GWF Energy LLC
GWF Tracy Combined Cycle Project
08-AFC-07 - COC Transmittal

- **Request for Administrative Approval – Temporary Lay Down Area**

Re: GWF Tracy (08-AFC-07) Temporary Lay Down Area Expansion

EROSION AND SEDIMENT CONTROL PLAN

DRAWING NO	REV
C8.1	7

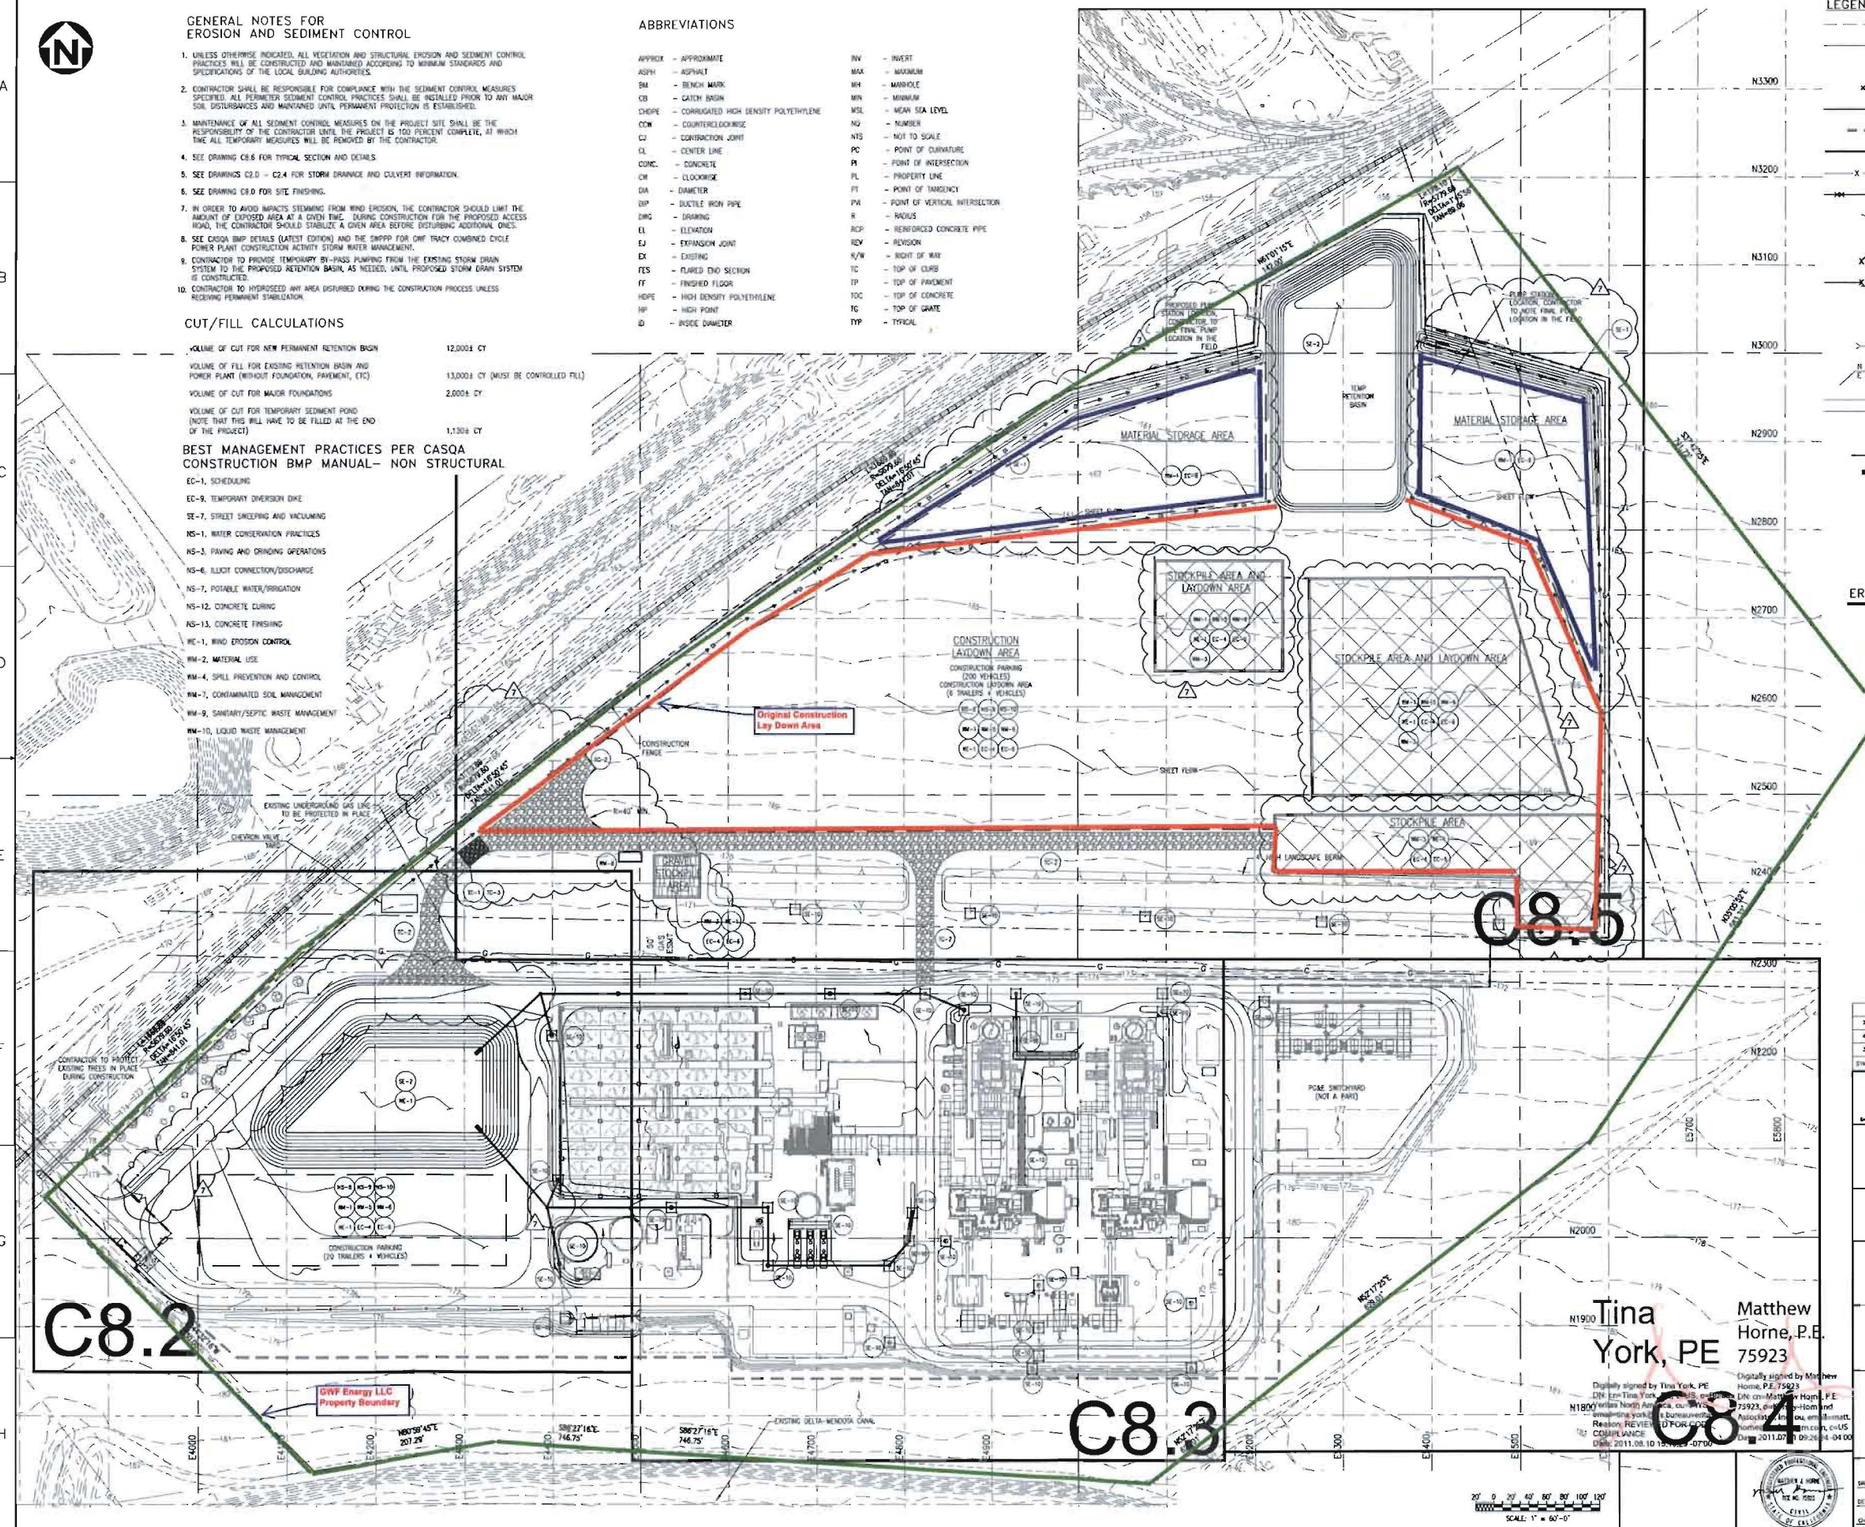
Figure 1 (see attached) provides a drawing that shows GWF Energy's property boundary of nominally 40 acres, the nominal 12.3 acres of original construction parking and lay down/construction area and the additional 5.45 acres of land that GWF requests be approved for construction material storage.

5. The Drainage, Erosion and Sedimentation Control plan has been revised to include Best Management Practices (BMPs) for the additional lay down area and as such will prevent any surface water accumulation from storm events from draining onto adjacent properties.

a. Bureau Veritas – North America the Chief Building Official for the project has reviewed and approved the site drainage drawings that reflect the changes to the lay down area.
